SMITH'S HIGHLANDS SUBDIVISION, BLOCK 2, **RESUBDIVISION OF LOTS 1 & 2**

APPLICATION NUMBER 3 DATE July 20, 2017
 APPLICANT Smith's Highlands Subdivision, Block 2, Resubdivision of Lots 1 & 2
 REQUEST Subdivision

DETAIL SITE PLAN

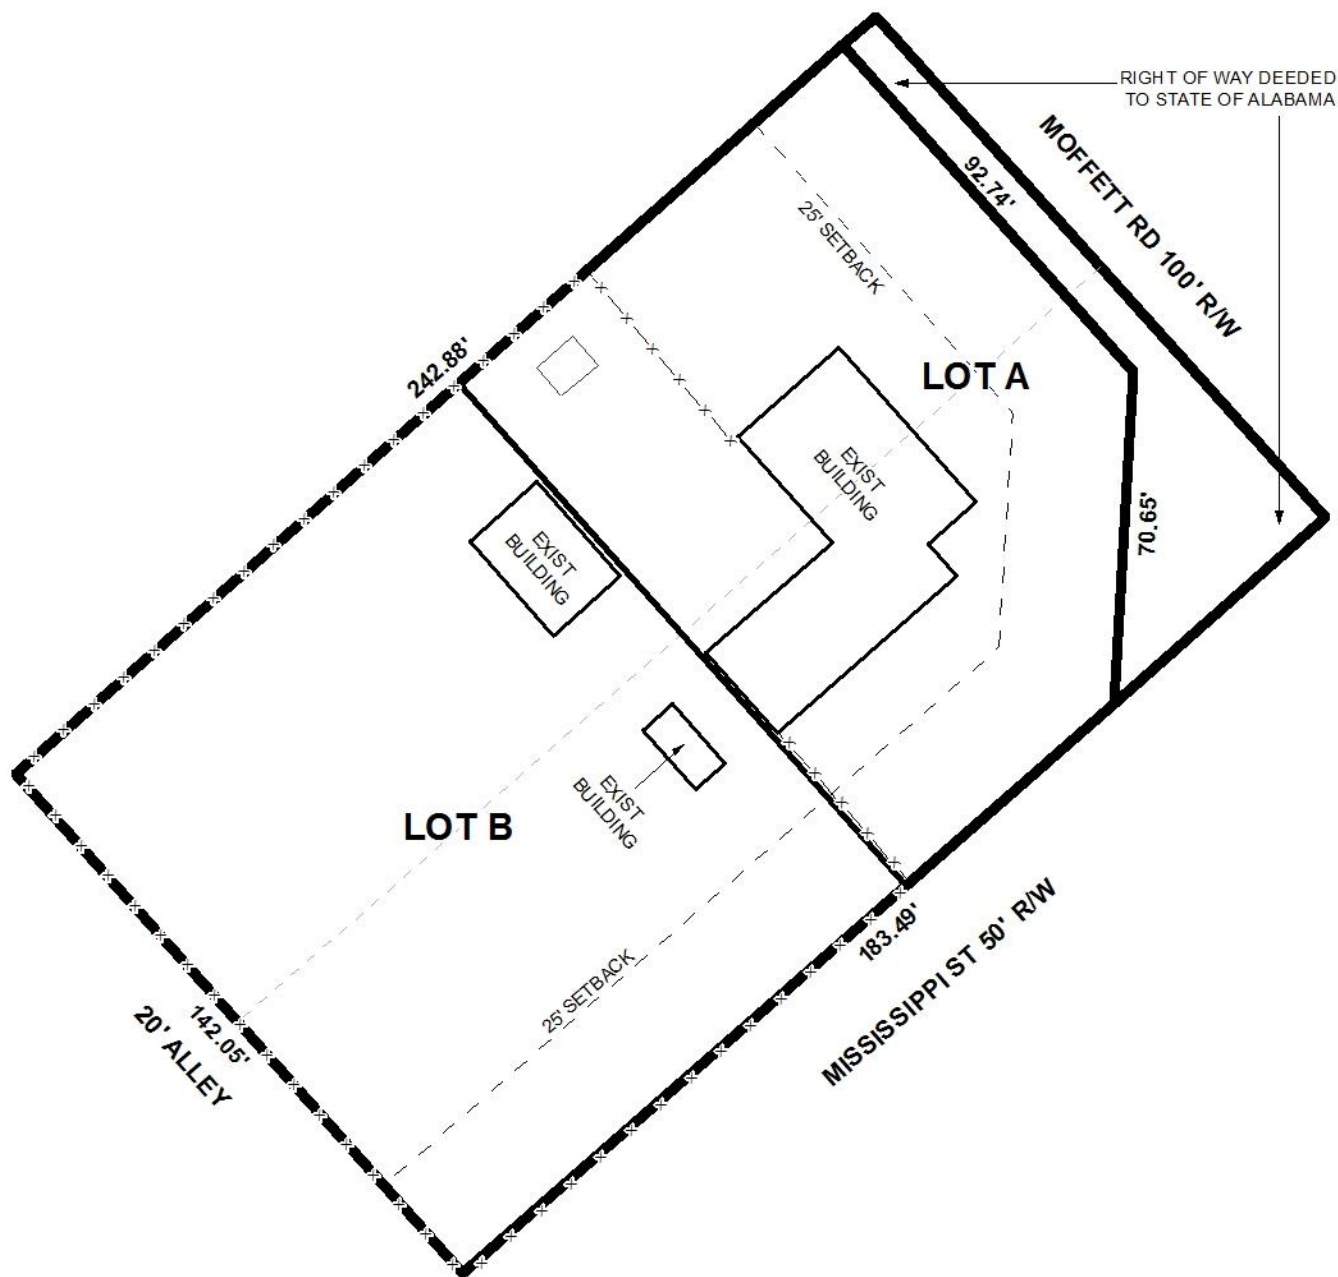
As previously stated, the applicant desires to relocate the interior lot line between the proposed lots A and B. The existing dwelling will be located solely on the proposed Lot A, and not straddle a property lot line as it does in its current configuration. And, the two existing ancillary shed structures and an existing carport will be sited on the proposed Lot B.

Being that the subject site has frontage along both Moffett Road and Mississippi Street, the applicant must ensure that the property lines at this intersection provide a compliant curb radius. The Final Plat, if approved, should be revised to illustrate a dimensioned curb radius in compliance with Section V.D.6. of the Subdivision Regulations.

The 25-foot minimum building setback line is depicted on the preliminary plat along Moffett Road and Mississippi Street, and as such, should be retained on the Final Plat, if approved.

As a means of access management, a note should be placed on the Final Plat stating that both Lots A and B are limited to one curb-cut each to Mississippi Street, with any changes in the size, location and design to be approved by Traffic Engineering and conform to AASHTO standards. Additionally, Lot A will be denied access along Moffett Road.

It should be noted that the site is commercially-zoned, and while a zero-foot side-yard setback is allowed by the Zoning Ordinance, a 10-foot setback is required when a residential use abuts a commercial use, even within a commercial district. Thus, the proposed subdivision may result in a Zoning Ordinance violation. Furthermore, the subdivision will result in accessory buildings on a lot without a primary structure, which is also a Zoning Ordinance violation.

Finally, the proposed location of the internal lot line will create Building and Fire Code compliance problems, as structures will require fire-rating of walls, soffits, eaves, and roofs due to the setback.

- 1) Creation of Zoning Ordinance setback violations for residential/commercial;
- 2) Creation of accessory buildings on a lot without a primary structure Zoning Ordinance violations; and
- 3) Building and Fire Code fire-rating/setback violations.
